MATHER AFB CALIFORNIA

SUBJECT: Final Fifth Five-Year Review Report, former Mather Air Force Base (AFB),

**FIFTH FIVE-YEAR REVIEW REPORT
FORMER MATHER AIR FORCE BASE
SACRAMENTO COUNTY, CALIFORNIA**

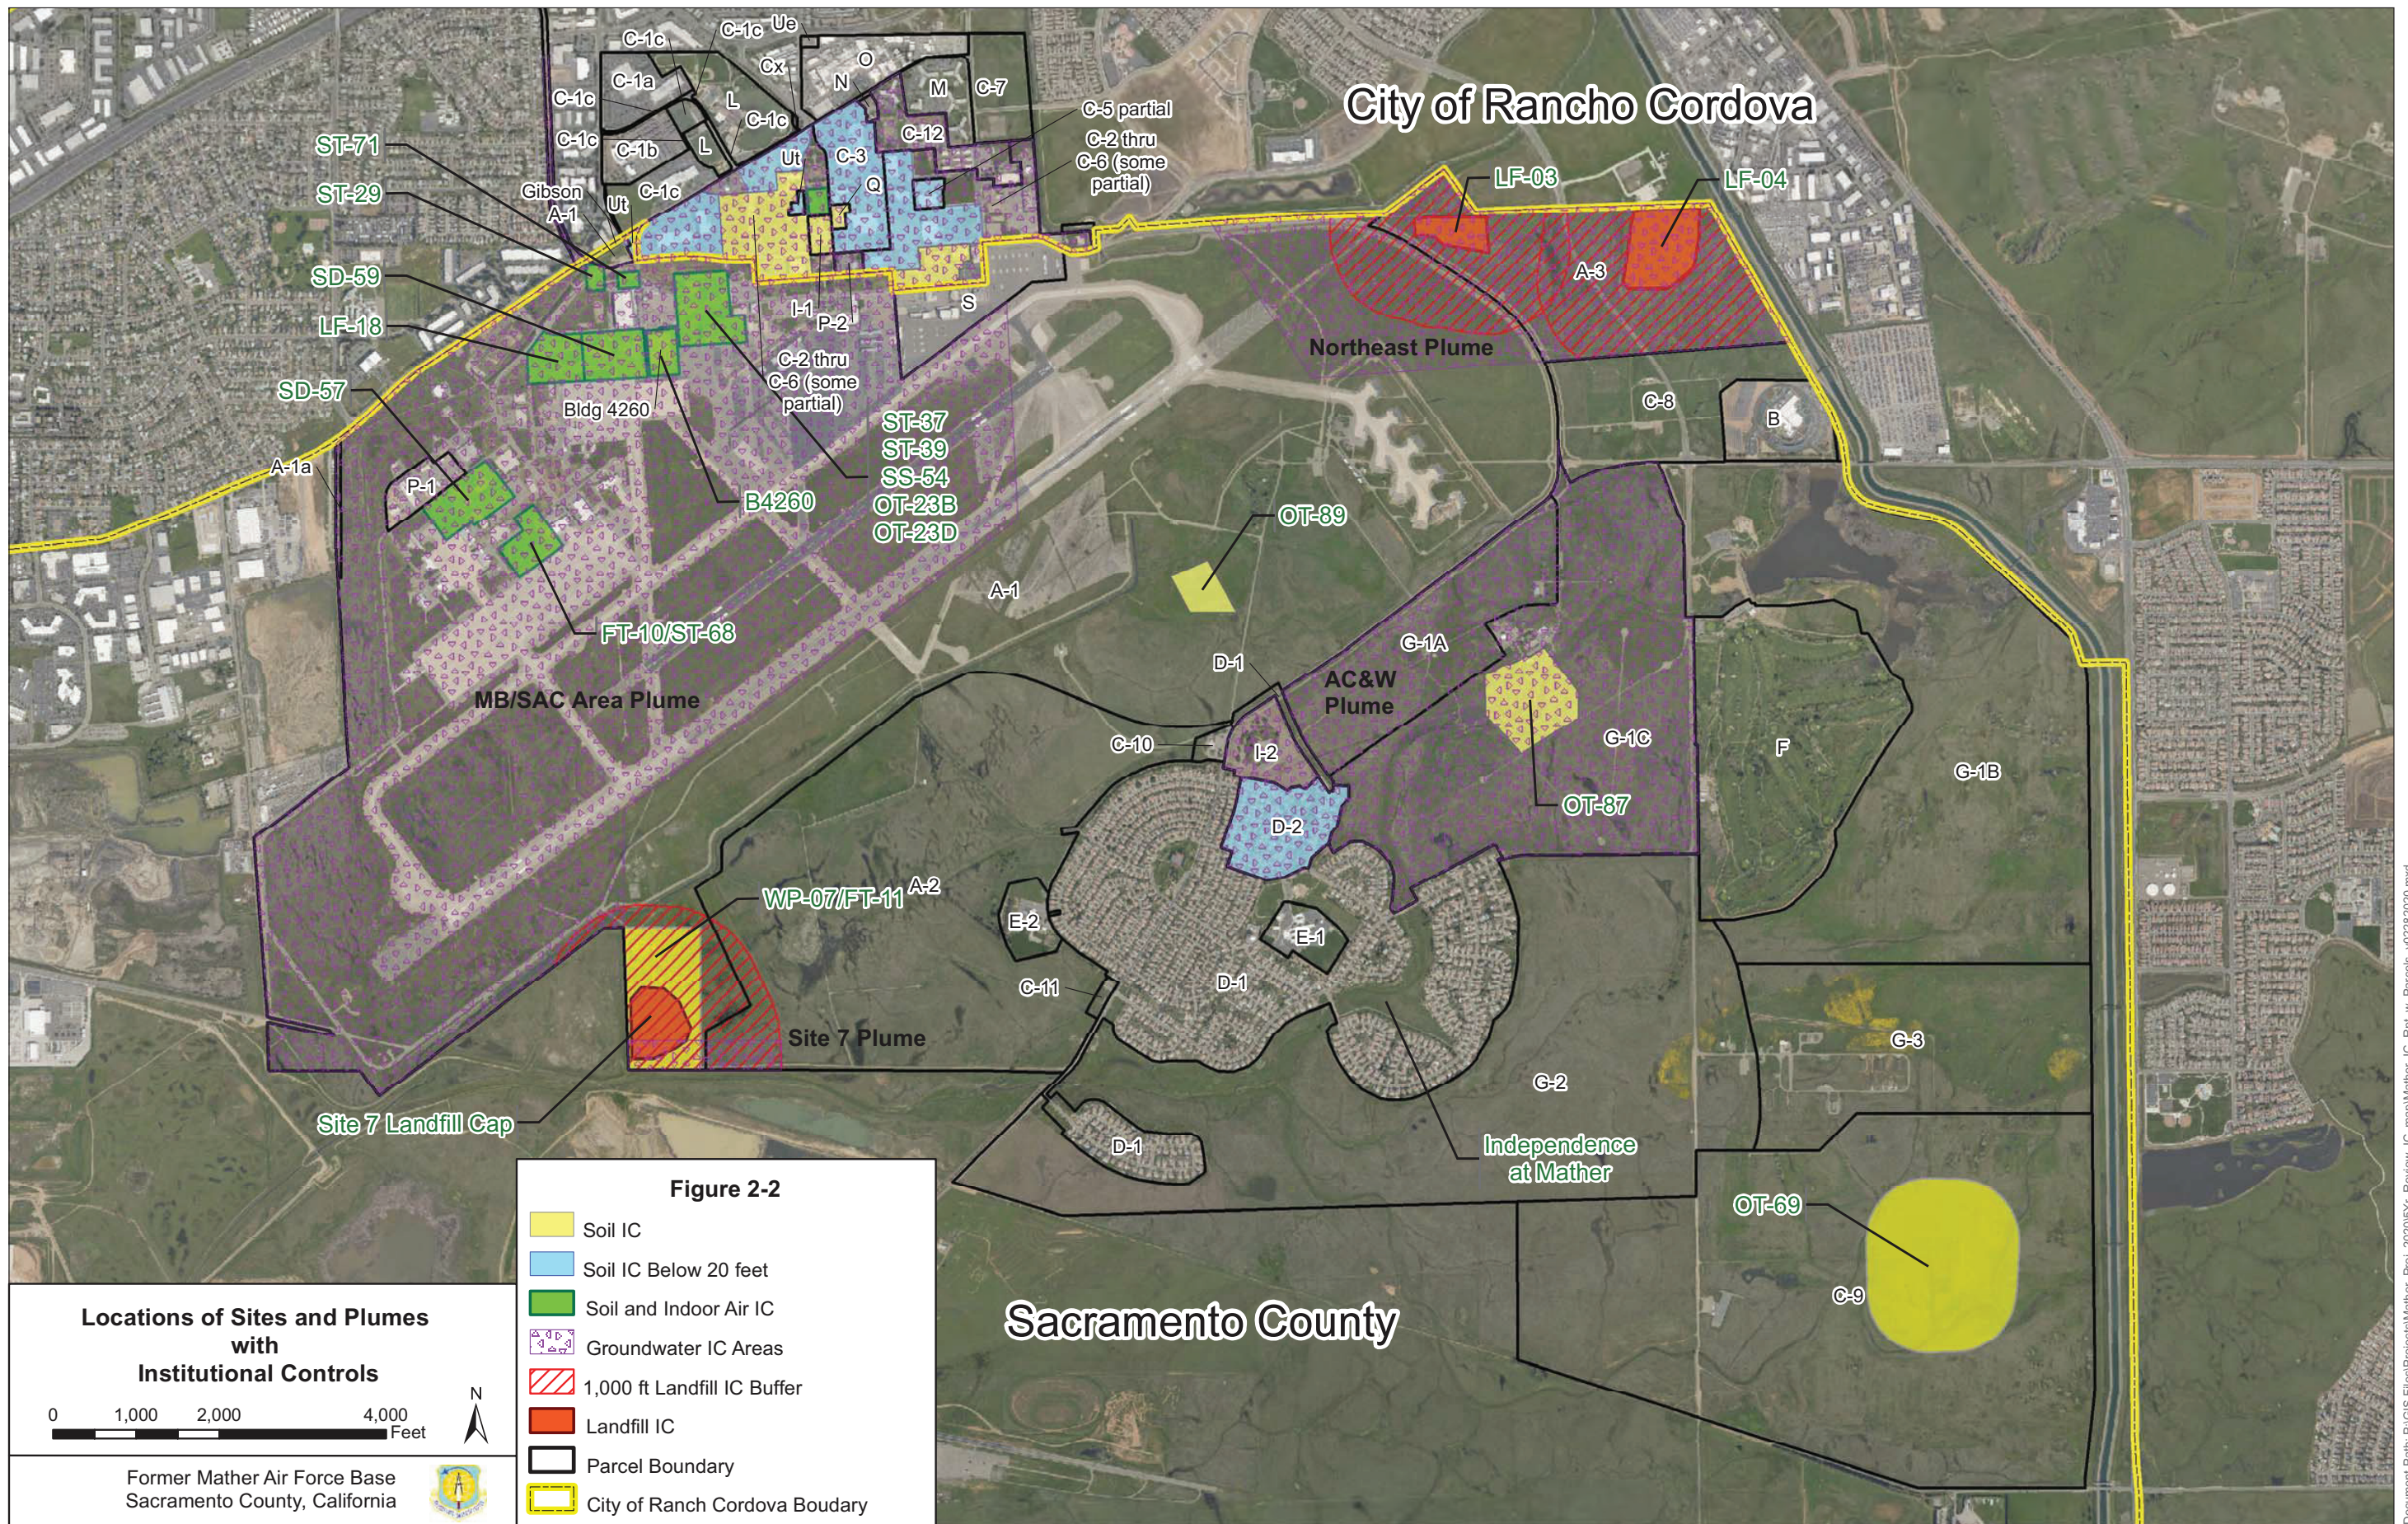
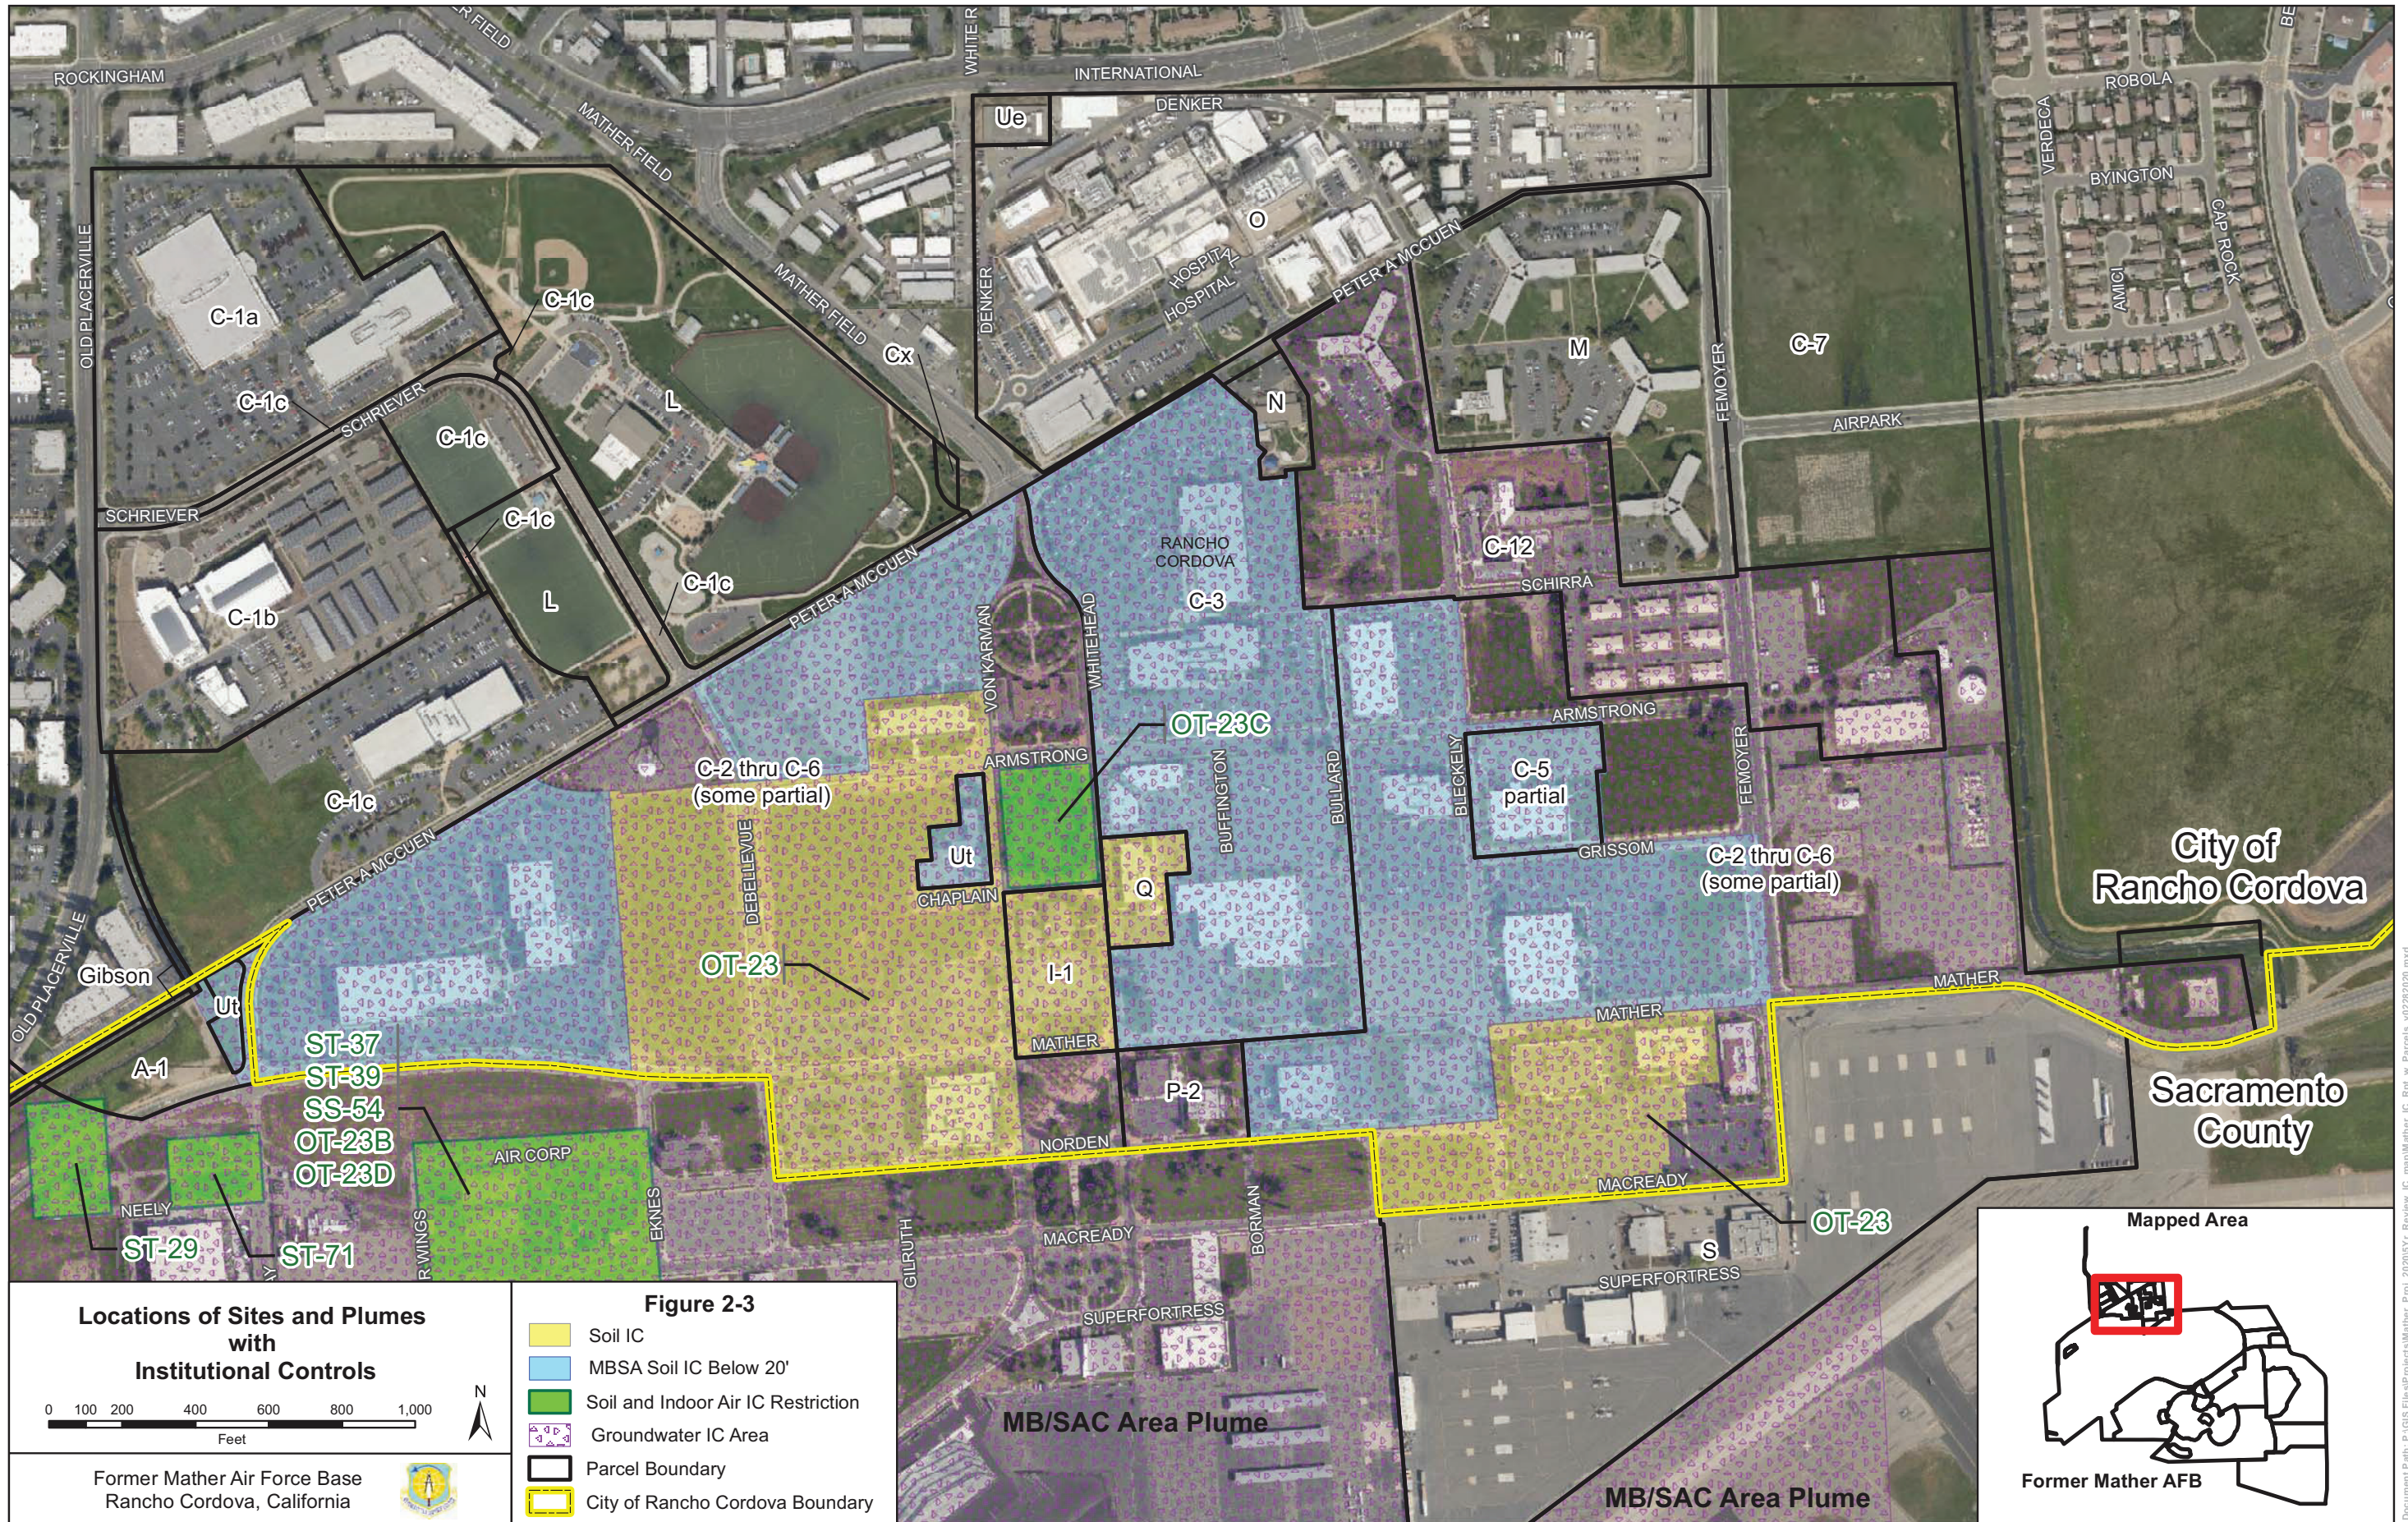
41. **PDF Pages 45-46, Figures 2-1 and 2-2:** The Landfill 1,000-foot buffer is mentioned in Figures 2-1 and 2-2 but not mentioned in the text. Please provide an update on the status of this IC in the text of the document. Additionally, does this IC cover all land or existing structures within 1,000 feet, or only new construction?

The ICs for the landfills are described in Sections 2.2.3 and 2.2.4. The ICs require “future landowners to obtain approval for any changes in land use or site improvements within 1,000 feet of a landfill.” The landfill buffers were applied only to property within the boundaries of the former Mather AFB, as shown in Figures 2-1 and 2-2 (AFRPA, 2009a; AFRPA, 2010a). Sections 2.2.3 and 2.2.4 were revised to indicate that the 1,000-foot buffer was applied only to property within the boundaries of the former Mather AFB.
